## DEPARTMENT OF TRANSPORTATION

### Federal Aviation Administration

**Airworthiness Directives; Bombardier Model CL-600-2C10 (Regional Jet Series 700, 701, and 702) Airplanes, Model CL-600-2D15 (Regional Jet Series 705) Airplanes, and Model CL-600-2D24 (Regional Jet Series 900) Airplanes**

**2006–14–05 Bombardier, Inc. (Formerly Canadair):** Amendment 39–14676. Docket No. FAA–2006–24074; Directorate Identifier 2005–NM–213–AD.

**Figure 1**  
LH side shown  
RH side opposite

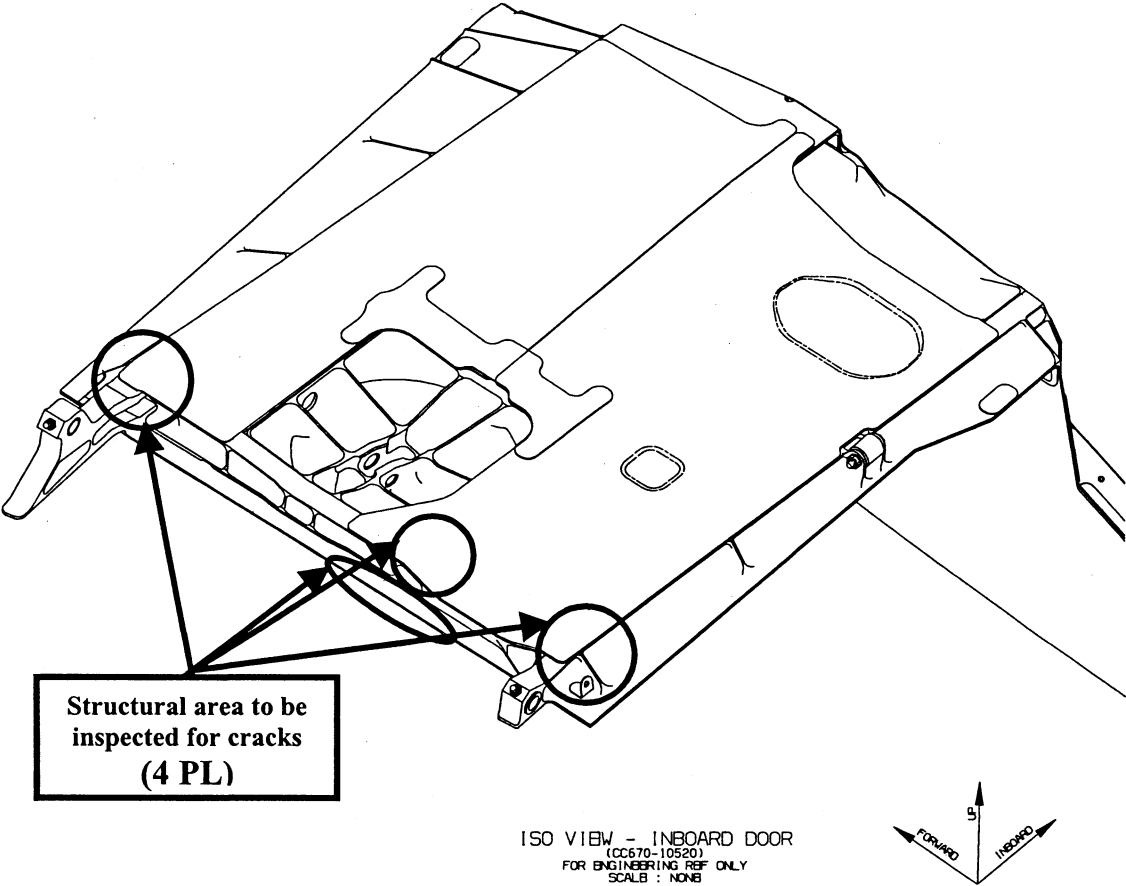
2D24 (Regional Jet series 900) series airplanes, S/Ns 15002 through 15990 inclusive: At the applicable time specified in paragraph (f) of this AD, perform detailed inspections of the lower panel, part number (P/N) CC670–10520, of the left- and right-hand MLG doors for the conditions and in the areas specified in paragraphs (g)(1), (g)(2), (g)(3), and (g)(4) of this AD; and Figures 1, 2, and 3 of this AD.

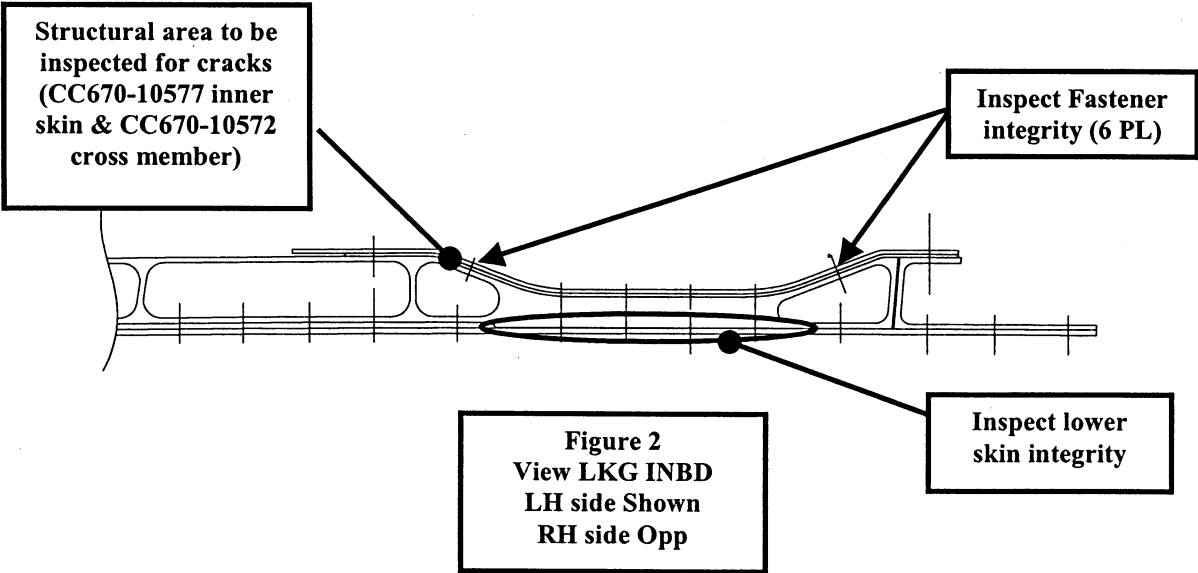
(1) Inspect the cross member, P/N CC670–10572, of the MLG door lower panel for cracking or deformation, in accordance with Figure 2 of this AD.

(2) Inspect the inner skin, P/N CC670–10577, of the MLG door lower panel at the cross member (P/N CC670–10572) for cracking or deformation, or pulled or missing fasteners, in accordance with Figure 2 of this AD.

(3) Inspect the outer skin, P/N CC670–10574, of the MLG door lower panel at the cross member (P/N CC670–10572) for cracking or deformation, or pulled or missing fasteners, in accordance with Figure 2 of this AD.

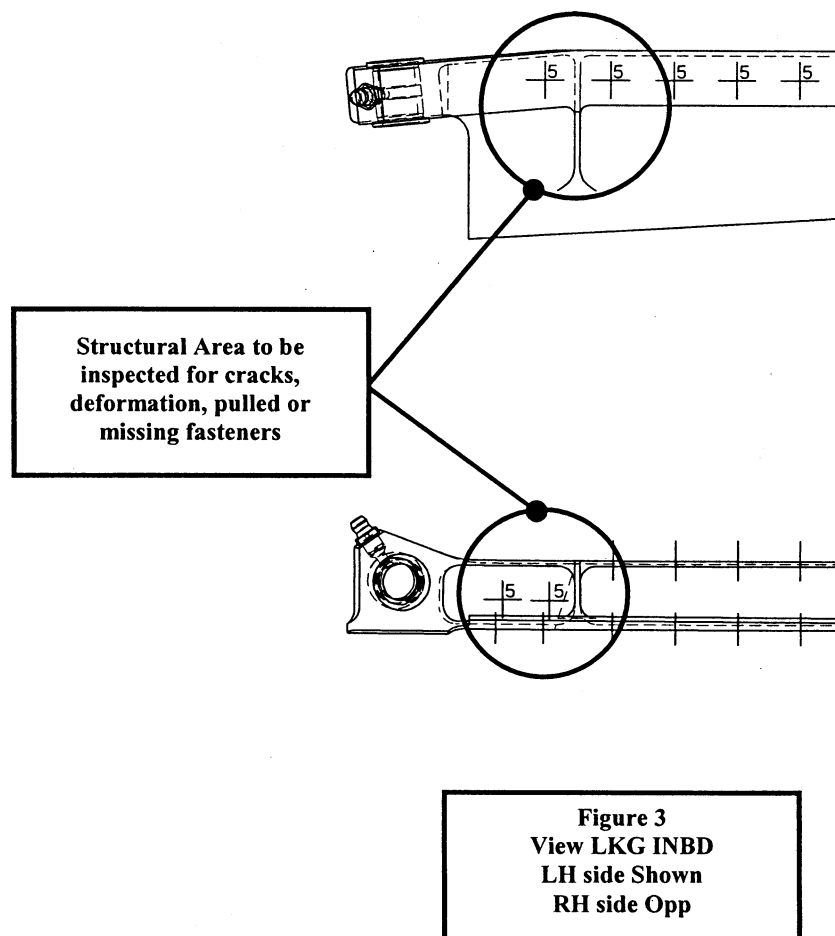
(4) Inspect the forward member, P/N CC670–10570, and aft member, P/N CC670–10571, of the MLG door lower panel for cracking or deformation, or pulled or missing fasteners, in accordance with Figure 3 of this AD. Figures 1 through 3 of this AD follow.
